EASTERN CORRIDOR SEGMENTS II AND III (PID 86462)

COMBINED LINWOOD/EASTERN INTERCHANGE & US 50/RED BANK INTERCHANGE FOCUS AREAS ADVISORY COMMITTEE MEETING NOTES

February 14, 2018
May 22, 2018
September 7, 2018
December 12, 2018

Figure X-2B-5
GRADE SEPARATED INTERCHANGE TO CONNECT
WILMER AVENUE TO WOOSTER ROAD

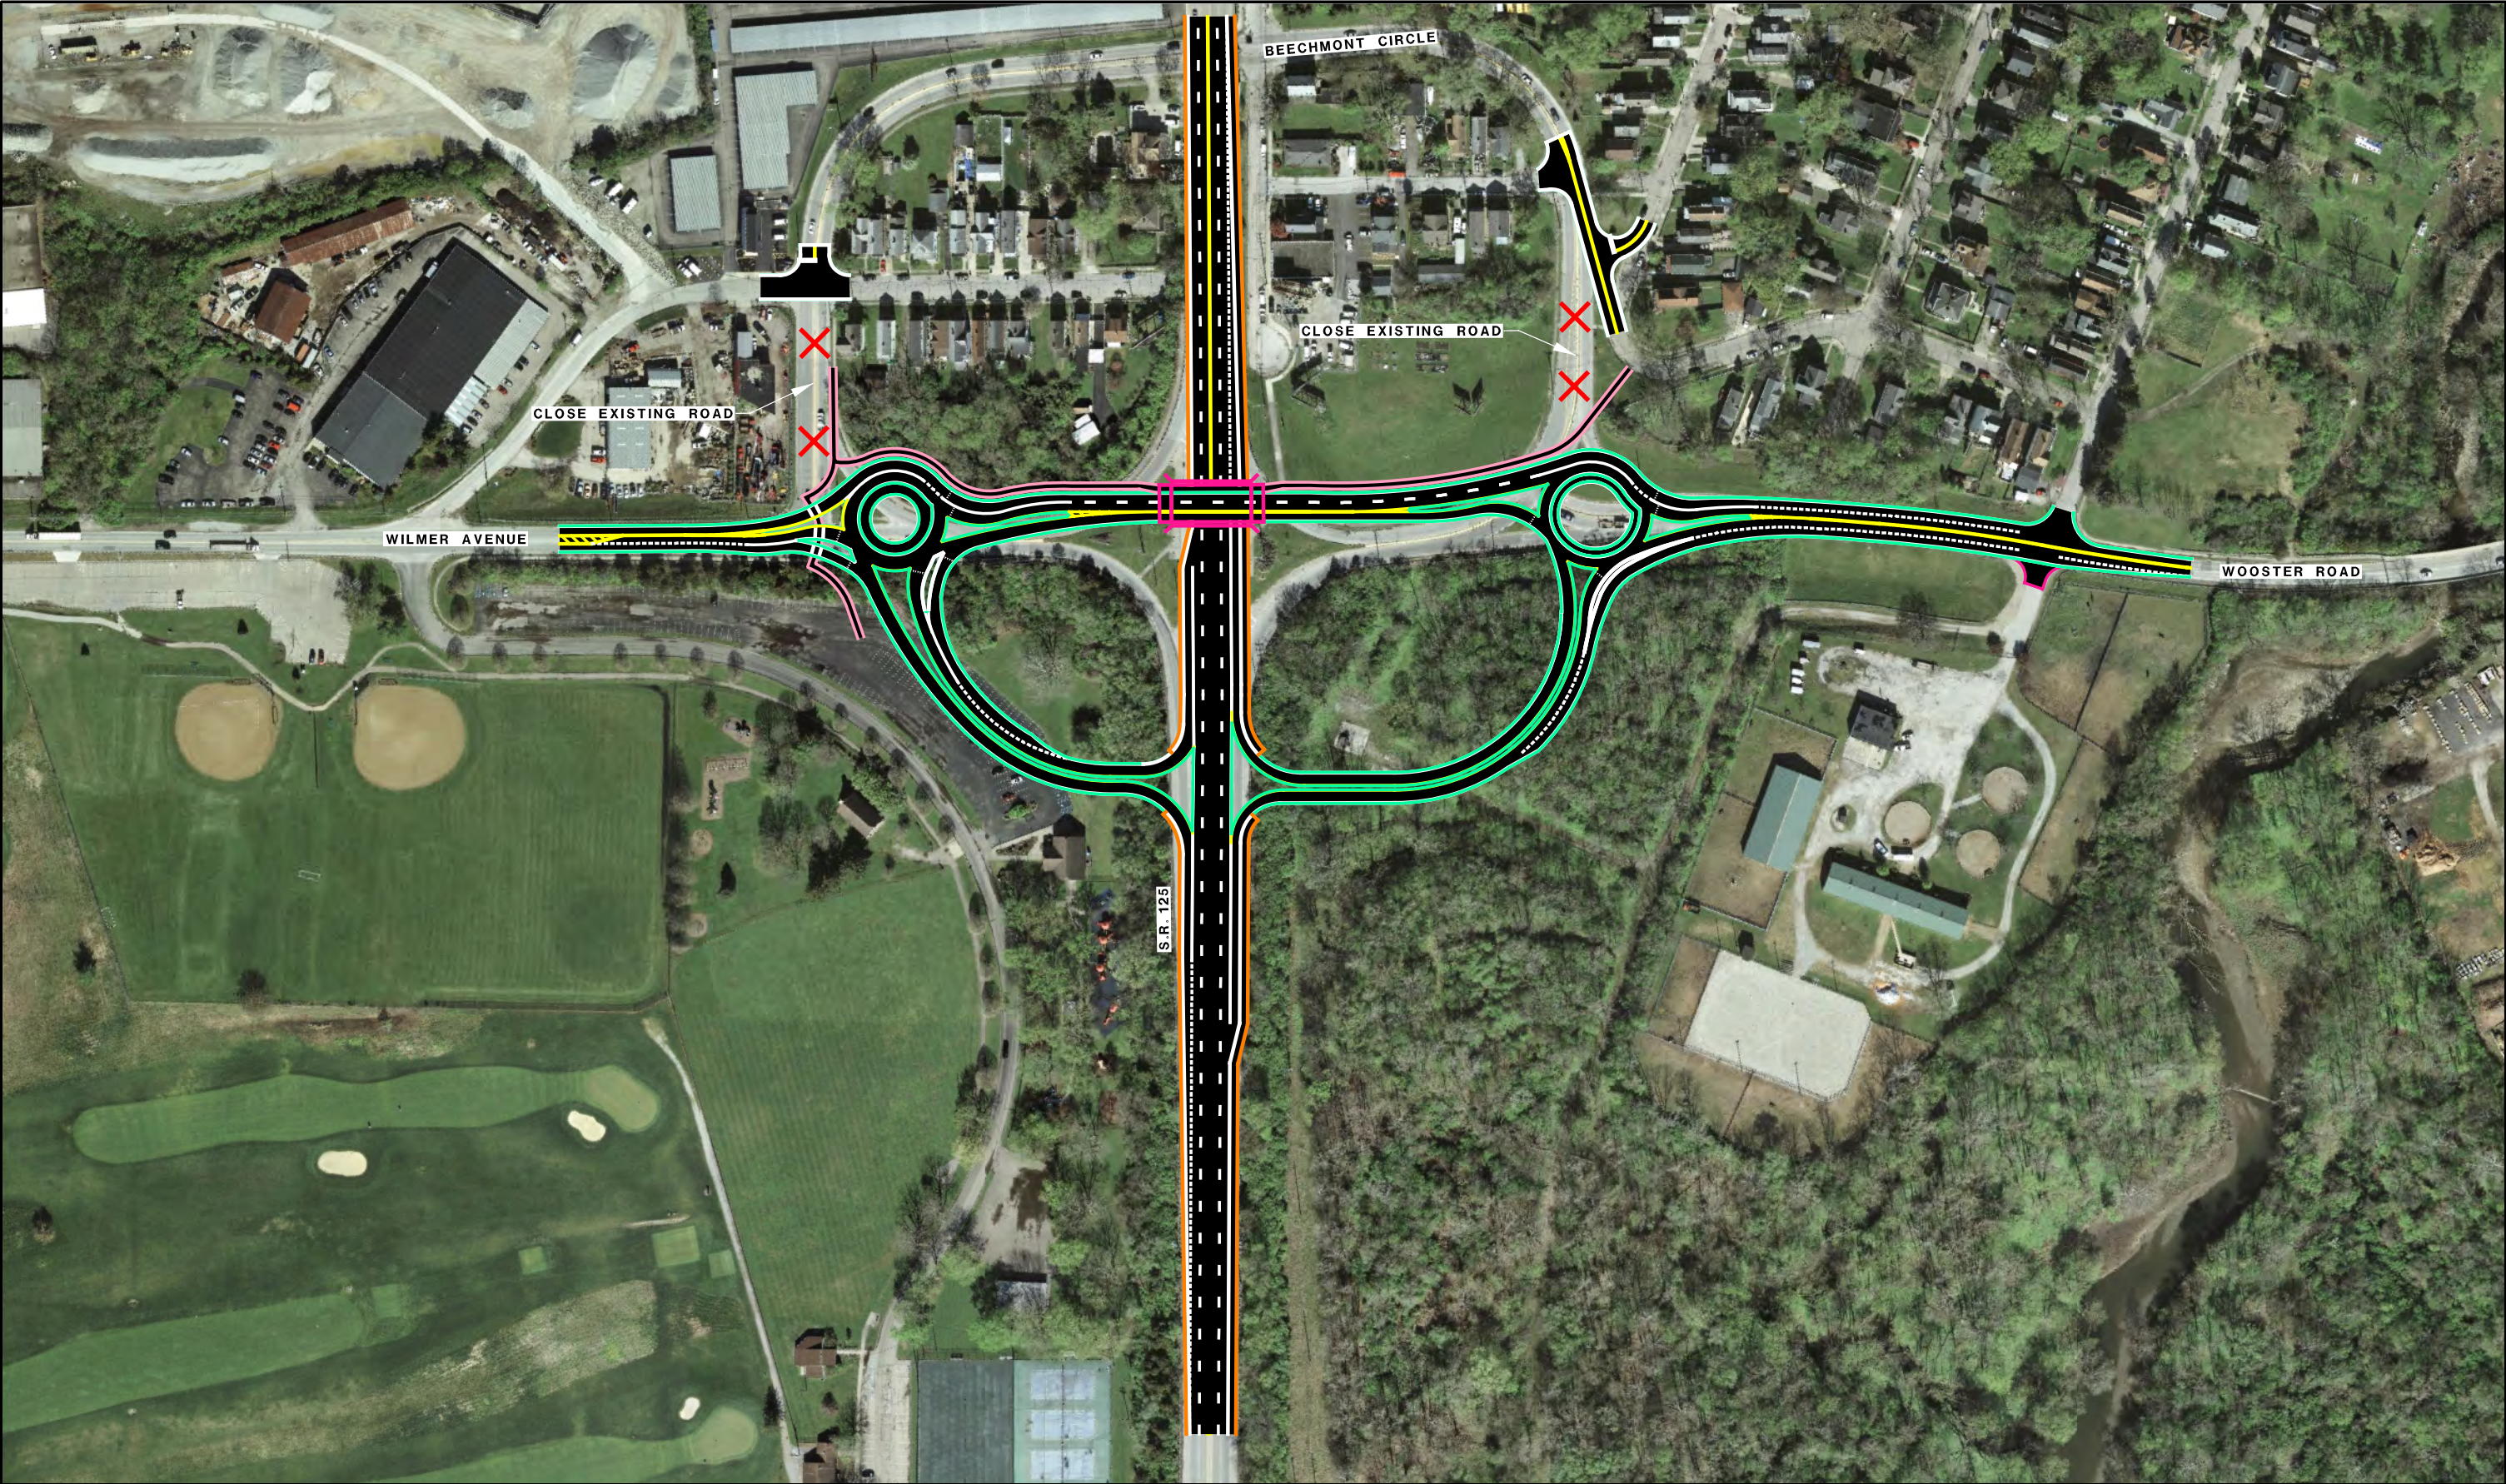
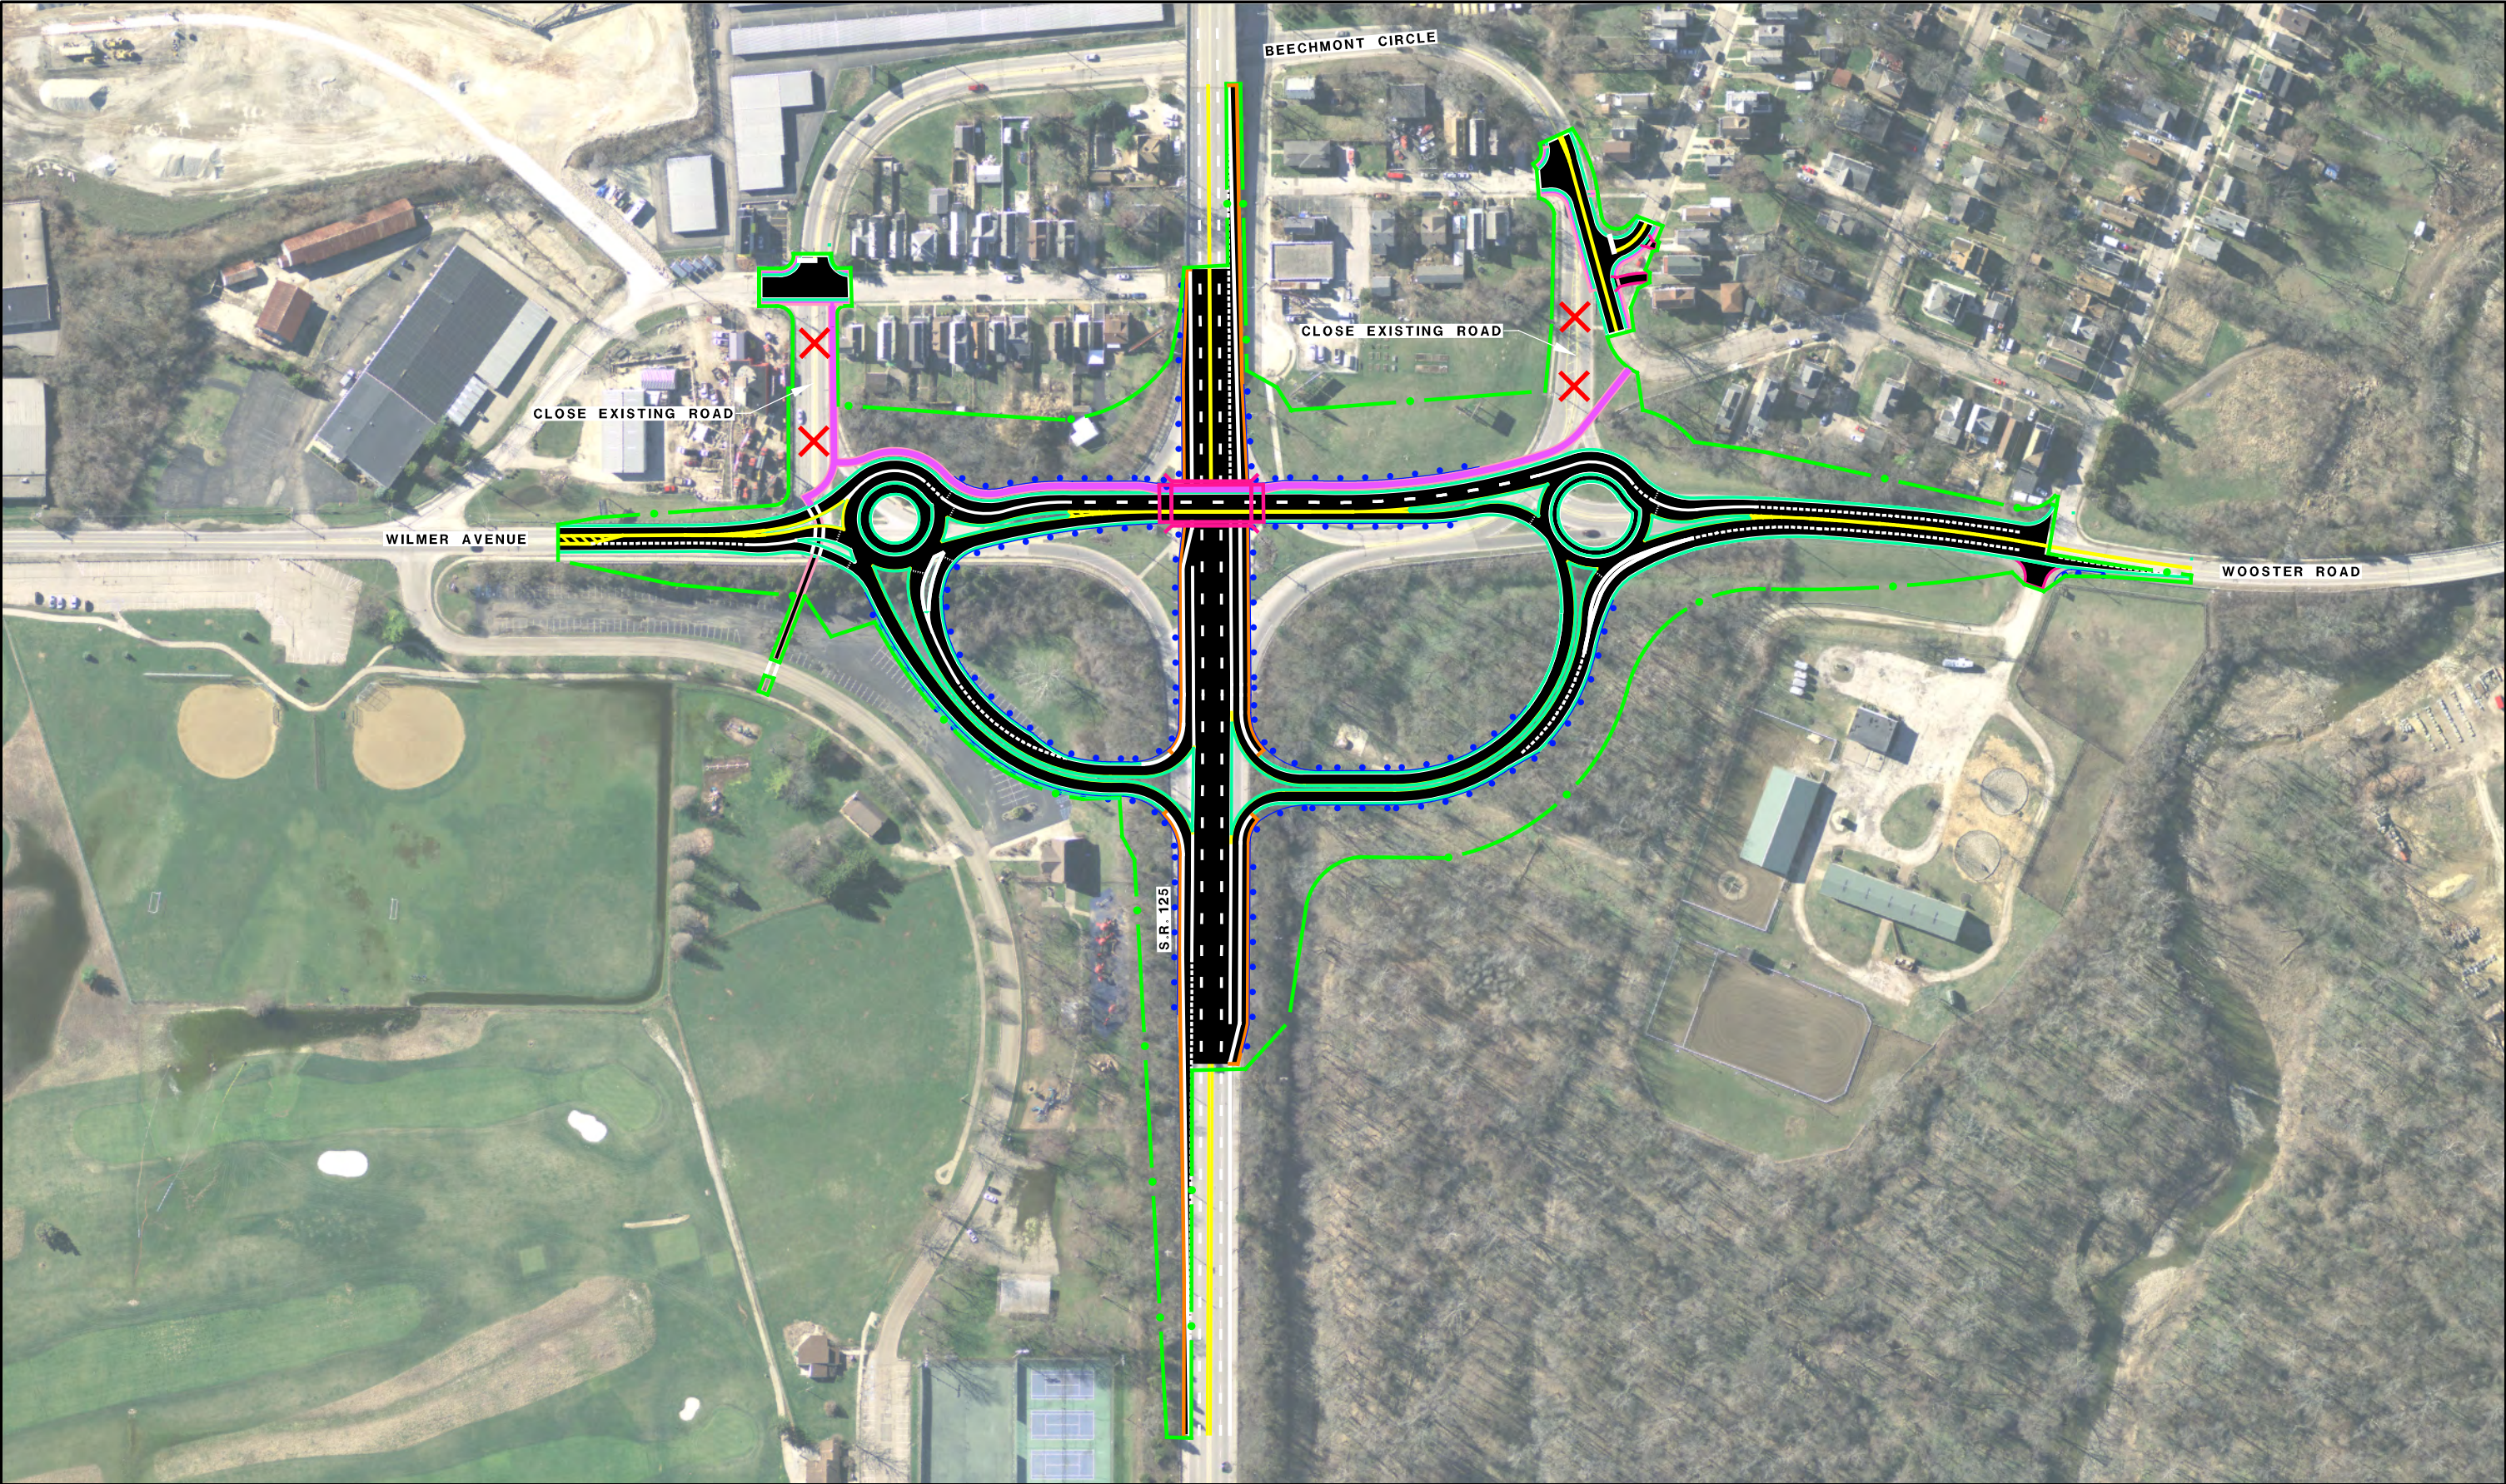
- This alternative should be evaluated with X-2b-2 and X-2b-2a.
- Traffic simulations show a significant increase in PM peak hour delays. Traffic traveling down Wooster to east on Beechmont left no gaps for other traffic to enter the roundabout.
- This concept would result in the loss of parking spaces in the Lunken Playfield parking lot, though the number of spaces impacted is not yet known.
- While an improvement over the No Build alternative, this option did not work as well as the signalized intersection options in traffic simulations and is more expensive.
- No additional comments received following the 9/7 meeting.

- No further study. Traffic simulations showed PM peak delays.

RECOMMENDATION: NO FURTHER STUDY

Figure I-26A & I-27A
 ROUNDABOUTS AT BEECHMONT CIRCLE INTERSECTIONS
 WITH WILMER AVENUE AND WOOSTER ROAD

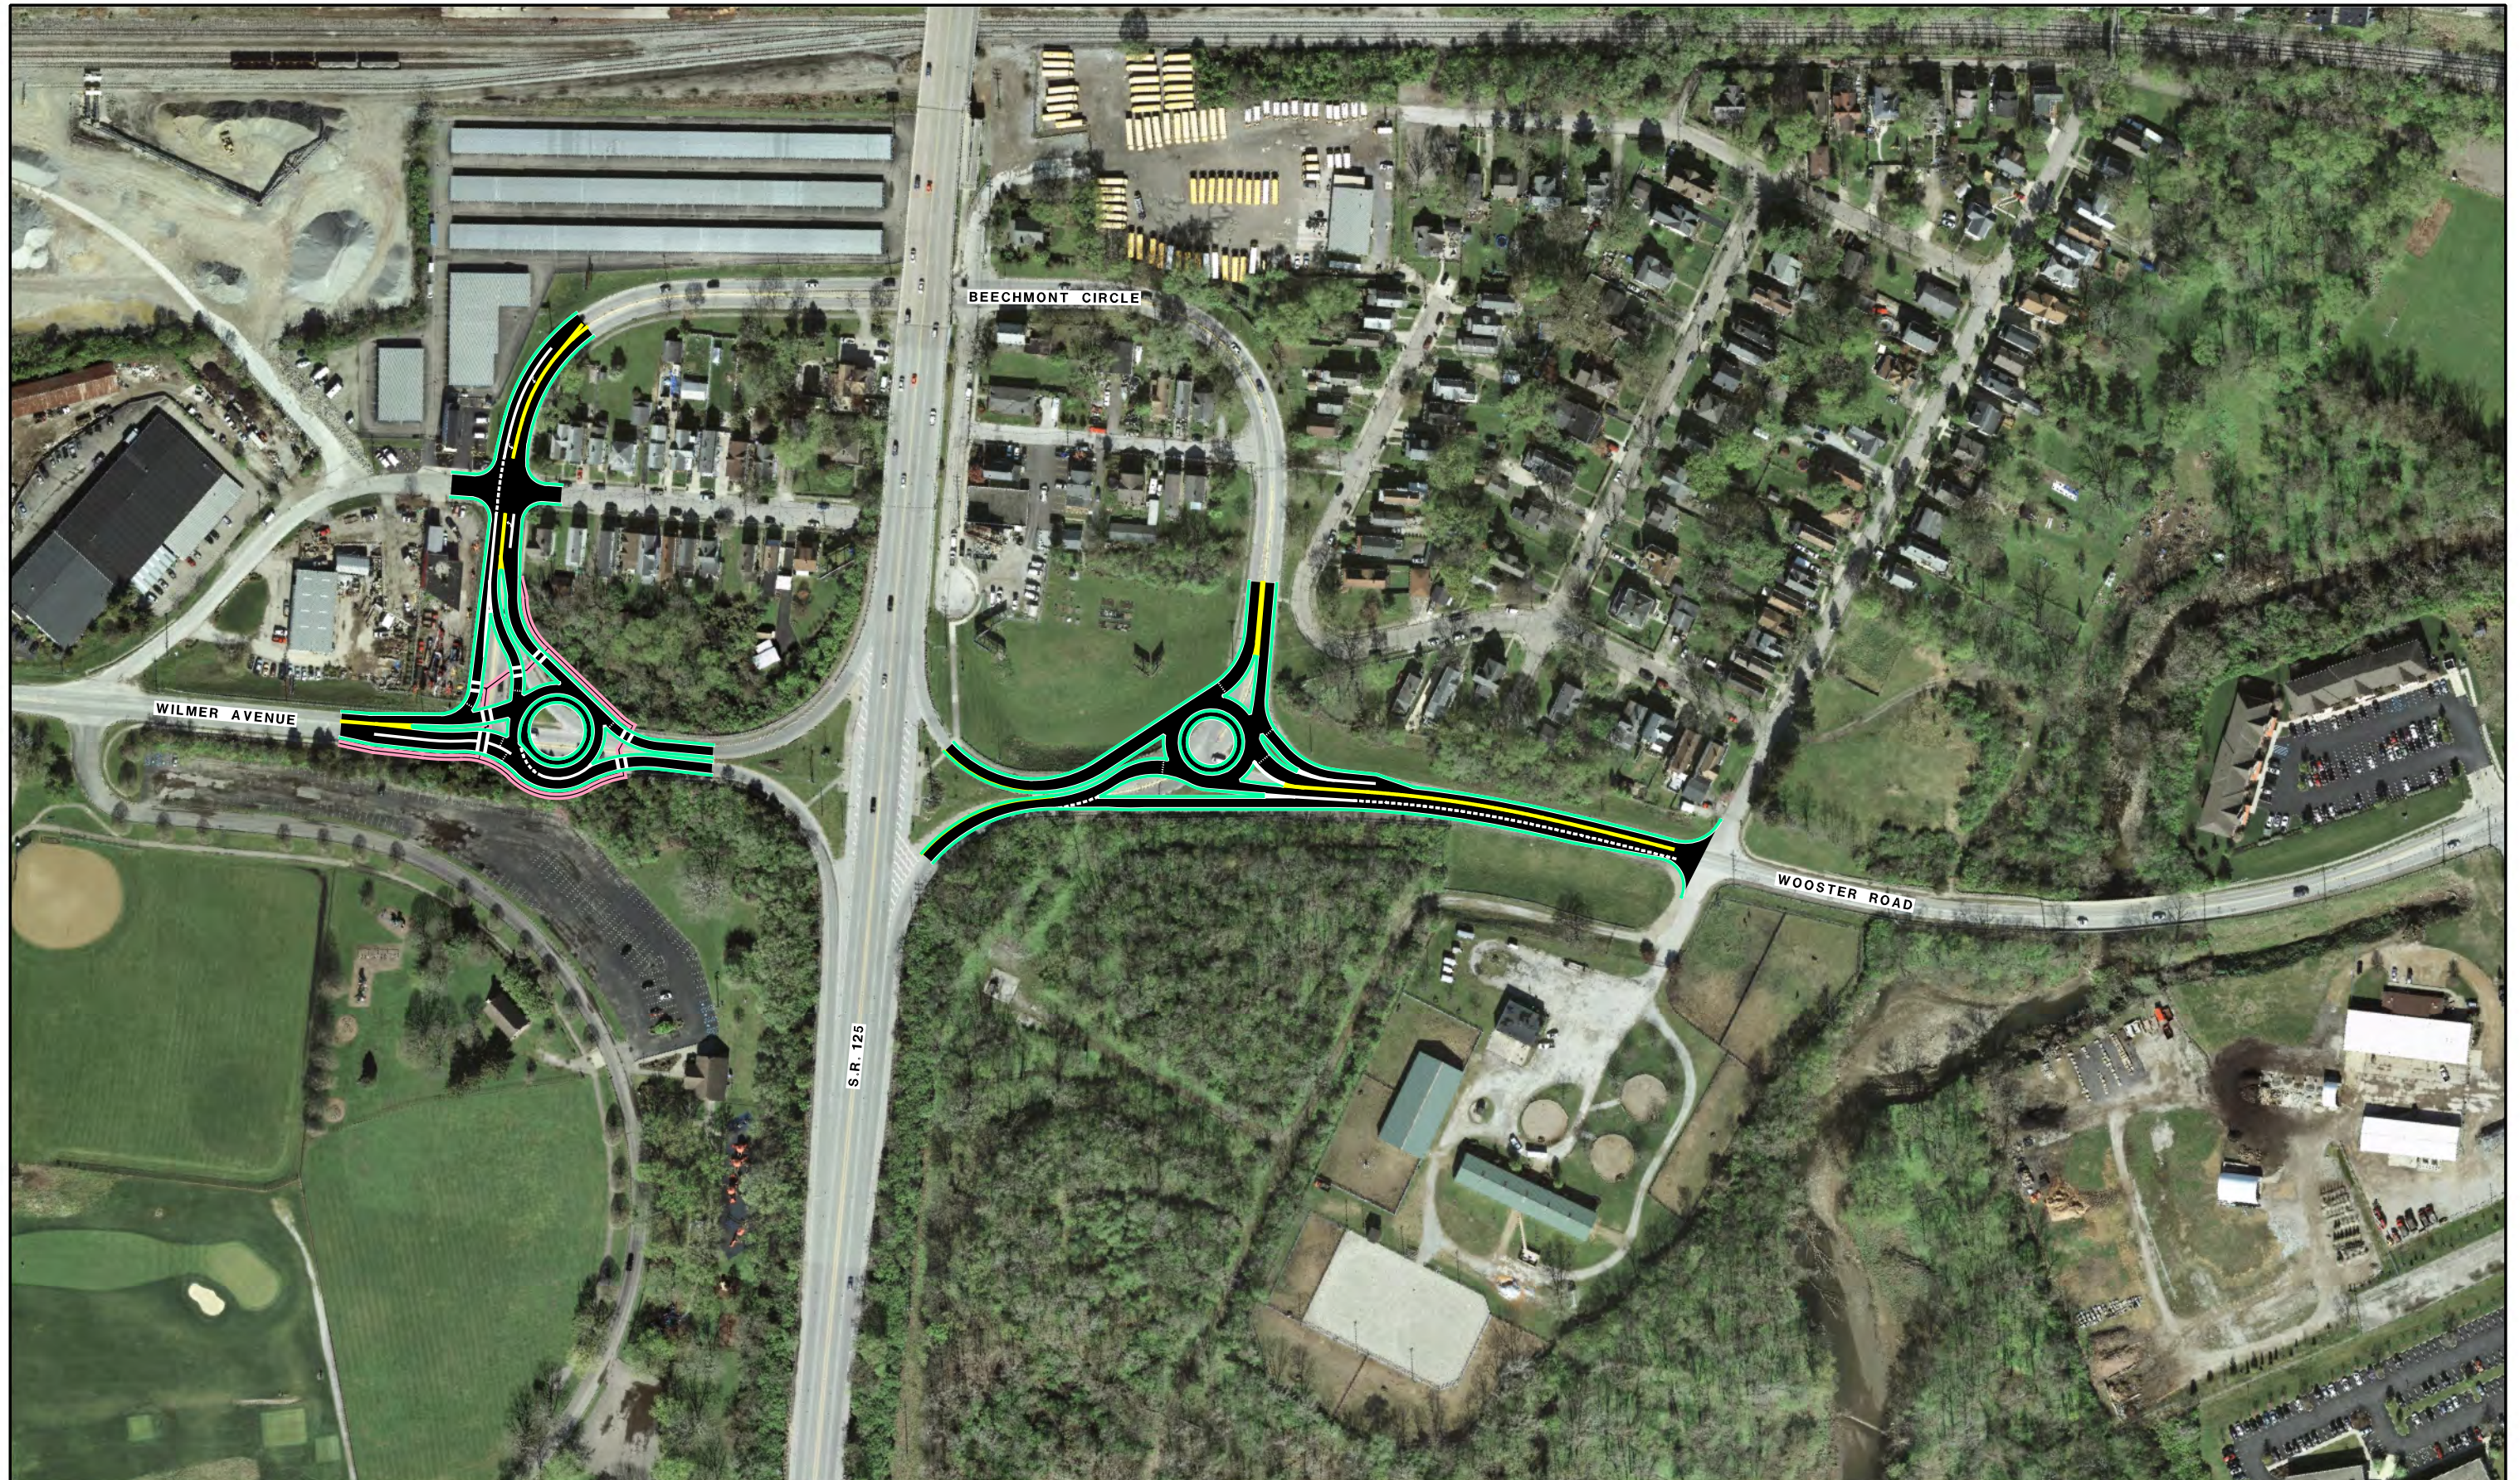
- Roundabouts help calm traffic and facilitate U-turns.
- Proposed modifications are smaller in scale than those proposed for other concepts.
- The roundabout would reduce delays by:
 - 57% during morning peak-hours
 - 11% during evening peak-hours
- No additional comments received following the 5/22 meeting.

- No further study. The roundabout would not solve the need of providing a more direct route across SR 125 between Wilmer and Wooster or of pulling traffic out of the neighborhood.

RECOMMENDATION: NO FURTHER STUDY
